Administrative Authorization Application

PROJECT NAME: JONES RICH + HUTCHINS - FUNERAL HOME - BODY COOLER ADDITION

PROJECT ADDRESS: 199 WOODFORD ST. CHART/BLOCK/LOT: 130-F-6

EXISTING FUNERAL HOME PROPOSING ADDITION (300 SF) FOR BODY COOLER

Plot Plan

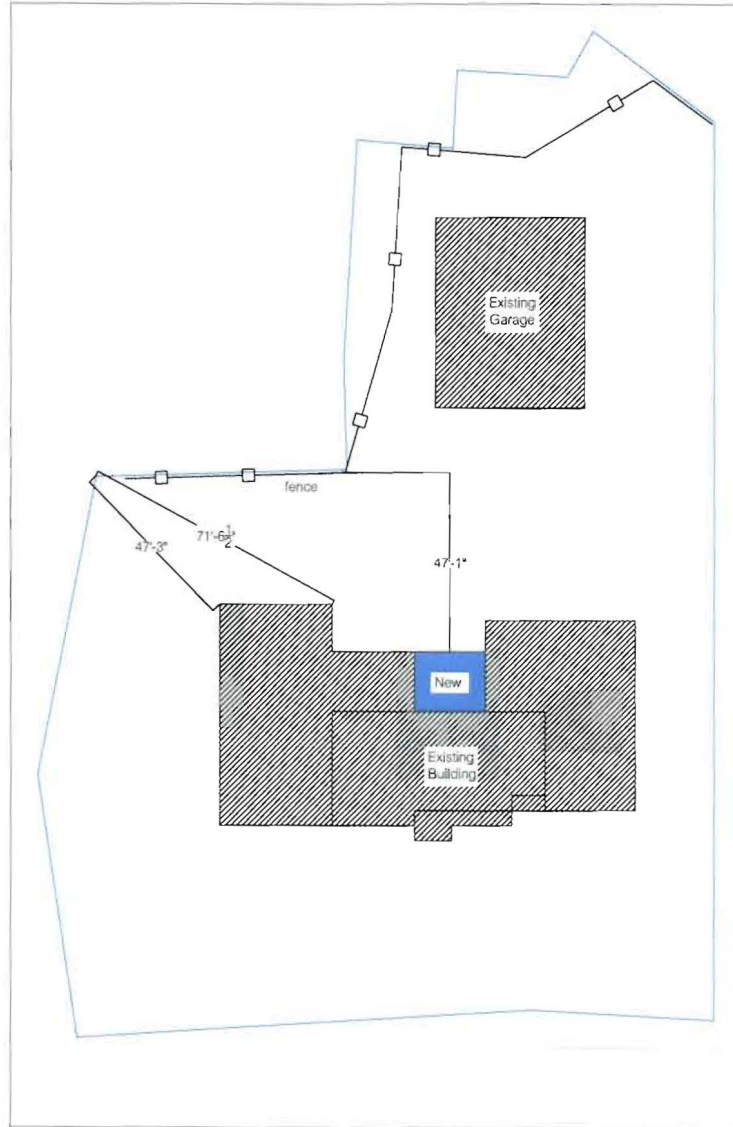
1. site plan showing the cooler, scaleable, showing lot boundaries; and
2. clarification of storm drain links; and
3. sound generation information from the manufacturer.

Any gutters or downspouts removed will be relocated and tie into existing drainage system

Hybrid Flex Submittal

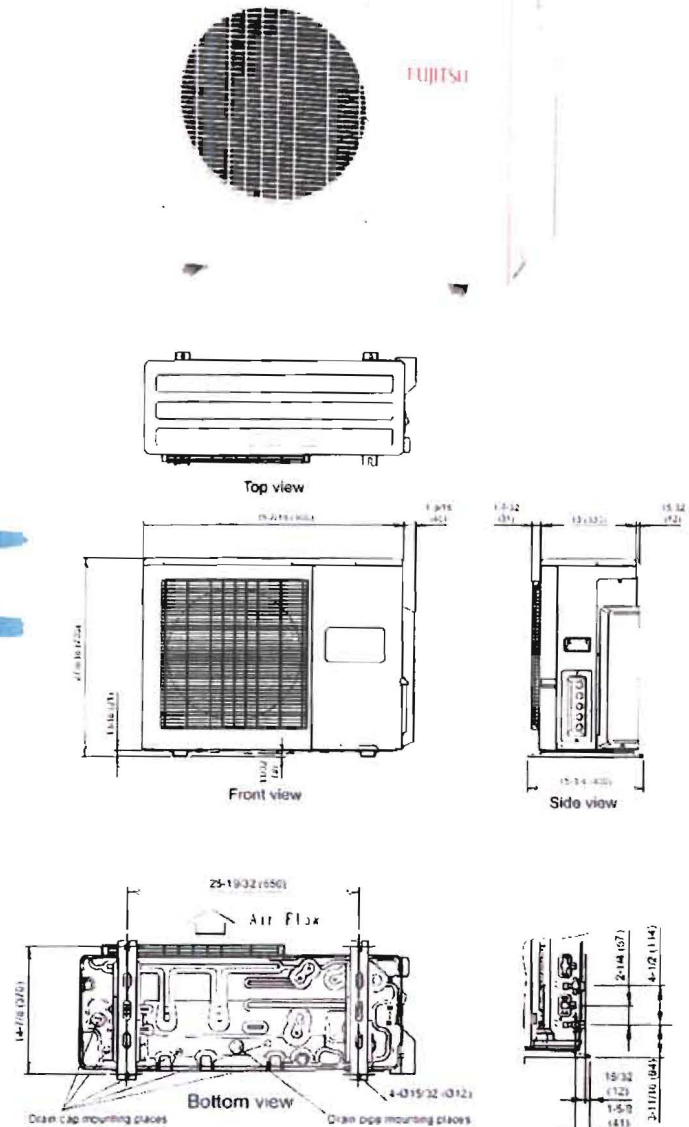
Copied to zoning - is OK - they have conditioned the building
 HFI Hybrid Flex Inverter FUJITSU permit
